The Technical Specifications contained in Appendices A and B, as revised through Amendment No. 281, are hereby incorporated into this license. The licensee shall operate the facility in accordance with the Technical Specifications.

The Technical Specifications contained in Appendices A and B, as revised through Amendment No. 258, are hereby incorporated into this license. The licensee shall operate the facility in accordance with the Technical Specifications.

Figure 3.4.15-1 (page 1 of 1)
Reactor Coolant DOSE EQUIVALENT I-131 Specific Activity Limit
Versus Percent of RATED THERMAL POWER With Reactor Coolant
Specific Activity $\geq 0.5 \mu\text{Ci/gm}$ DOSE EQUIVALENT I-131

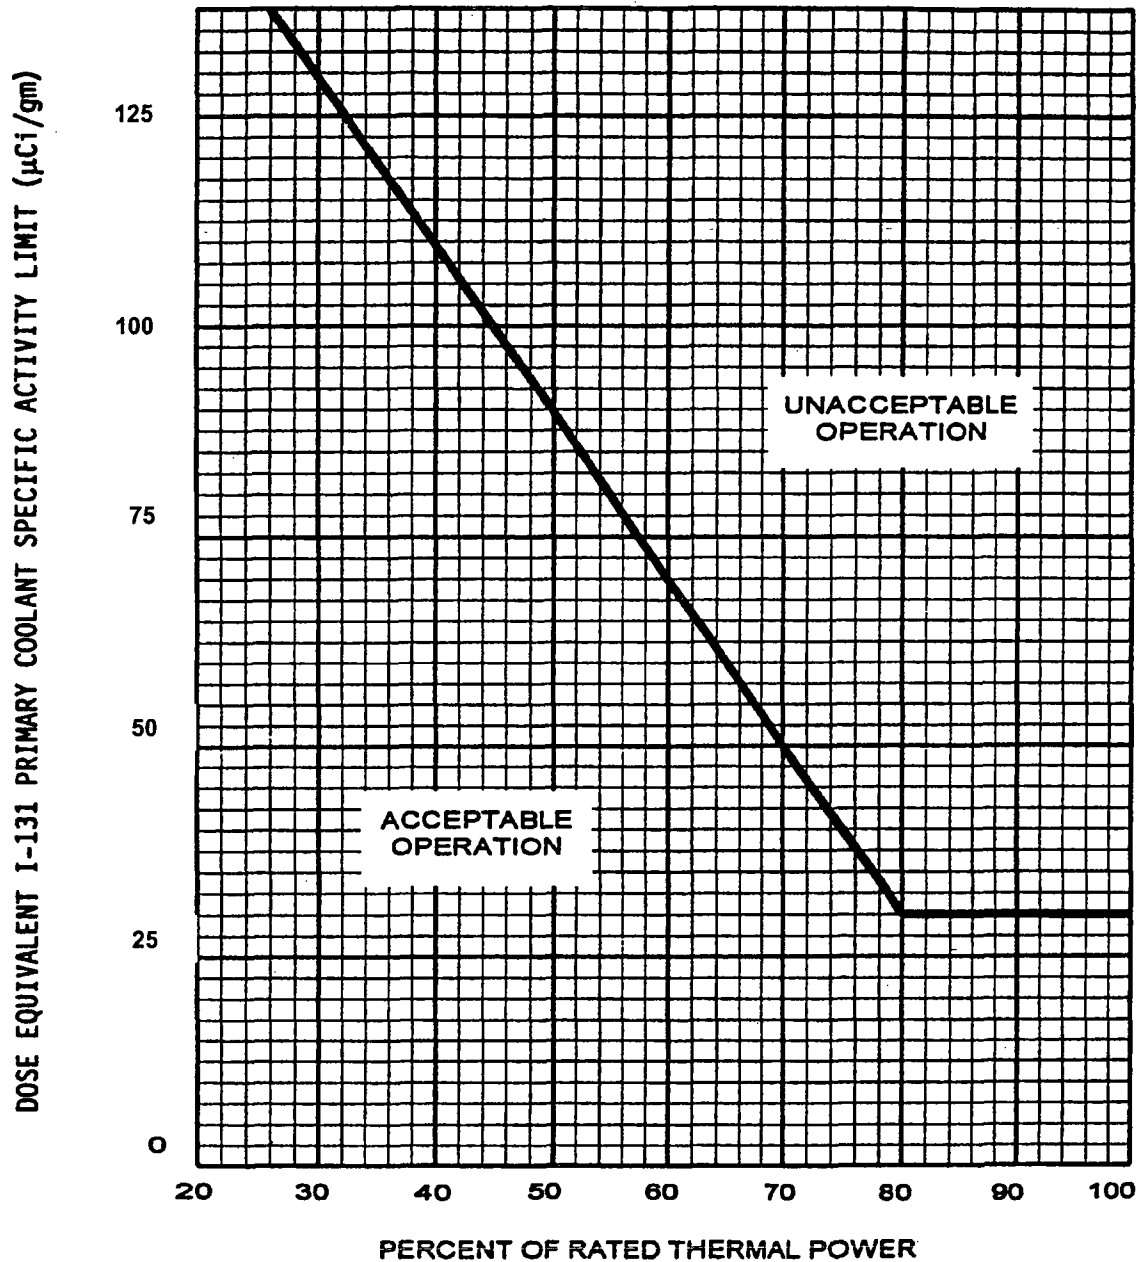
CONDITION	REQUIRED ACTION	COMPLETION TIME
A. DOSE EQUIVALENT I-131 > 0.5 $\mu\text{Ci/gm}$.	----- NOTE ----- LCO 3.0.4.c is applicable. -----	
	A.1 Verify DOSE EQUIVALENT I-131 within the acceptable region of Figure 3.4.15-1.	Once per 4 hours.
	<u>AND</u> A.2 Restore DOSE EQUIVALENT I-131 to within limit.	100 hours
